ACCESSION NBR: 8104280545 DOC. DATE: 81/04/23 NOTARIZED: NO DOCKET #
 FACIL: 50-244 Robert Emmet Ginna Nuclear Plant, Unit 1, Rochester G 05000244
 AUTH. NAME: AUTHOR AFFILIATION
 MAIER, J. E. Rochester Gas & Electric Corp.
 RECIP. NAME: RECIPIENT AFFILIATION
 CRUTCHFIELD, D. Operating Reactors Branch 5

SUBJECT: Forwards QA program info per 810224 request. Discusses transfer of welding & nondestructive exam engineer responsibilities & deletion of Revision 7, Figure 4.2-2, of util QA program.

Subject: Quality Assurance Program
R.E. Ginna Nuclear Power Plant
Docket No. 50-244

Figure IV.2-3
April 1981

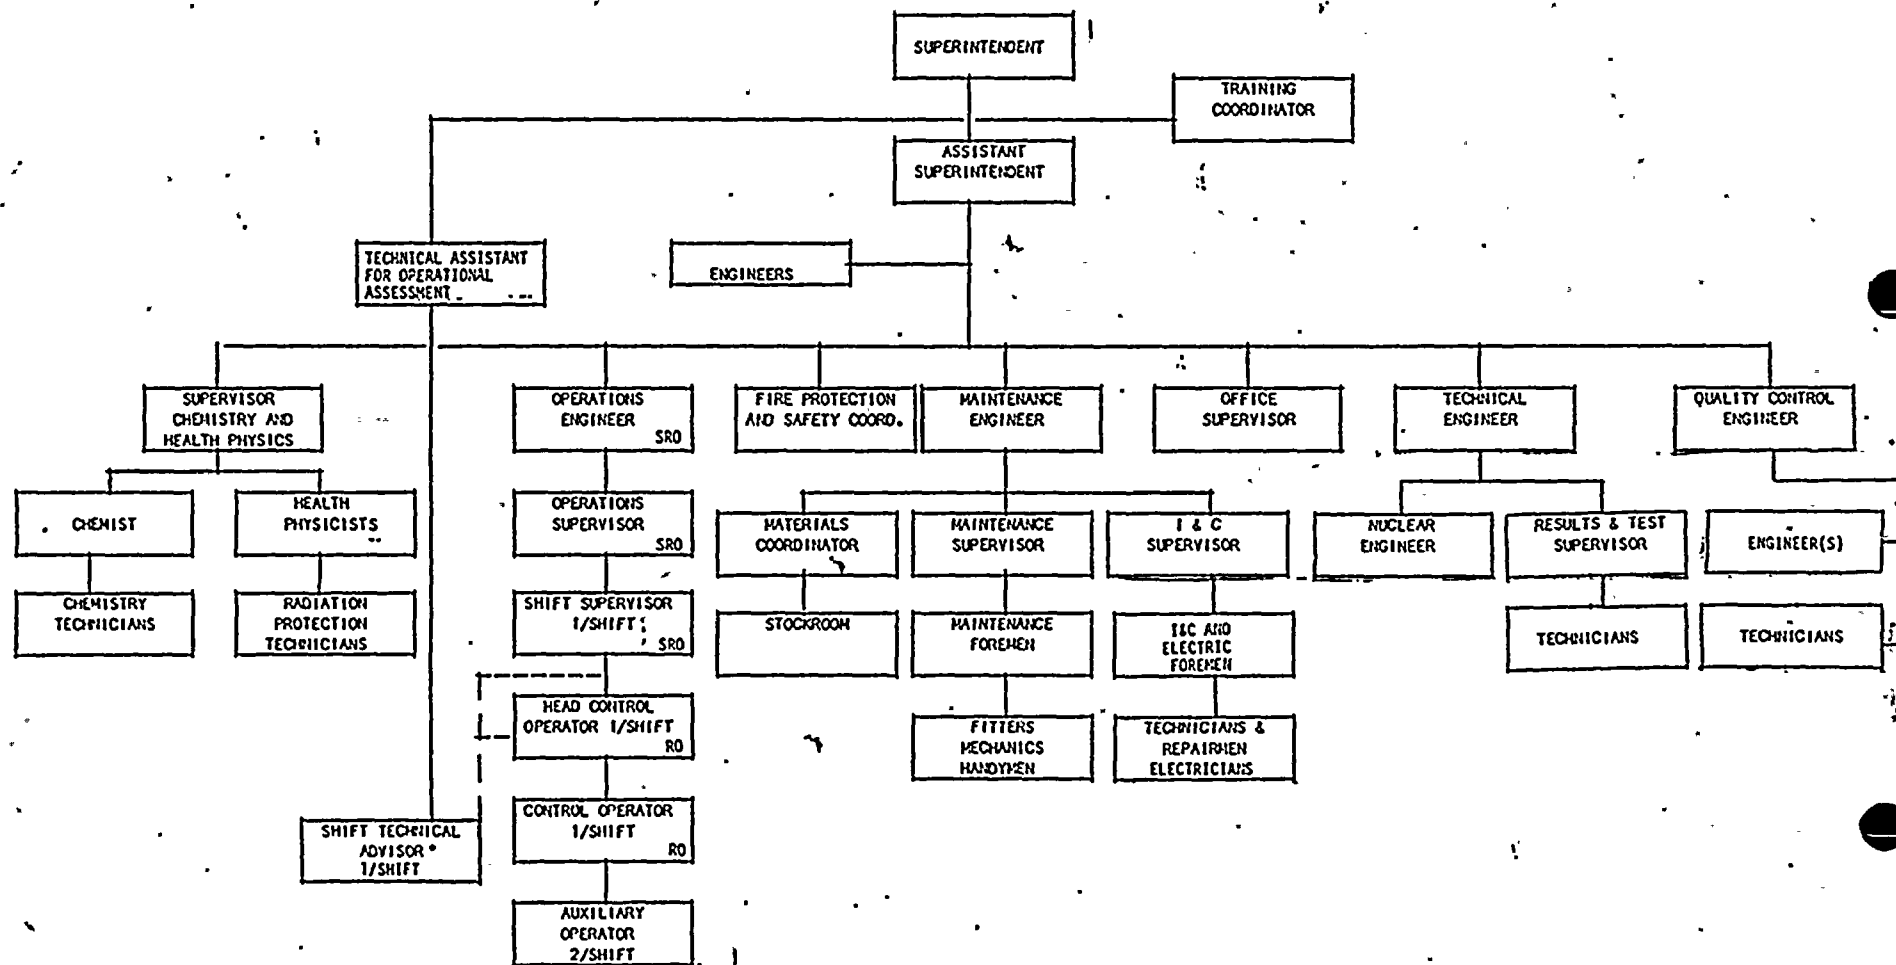
Discuss the Significance of Deleting the "Engineer"
Block Under the "Quality Control Engineer" Block from
Figure IV.2-3

The deletion, which occurred during changes to incorporate the positions of Shift Technical Advisor and Technical Assistant for Operational Assessment is being remedied by the re-insertion of the "Engineer(s)" block as shown on the attached Figure. The attached Figure IV.2-3 is to replace that which was provided with the November submittal.
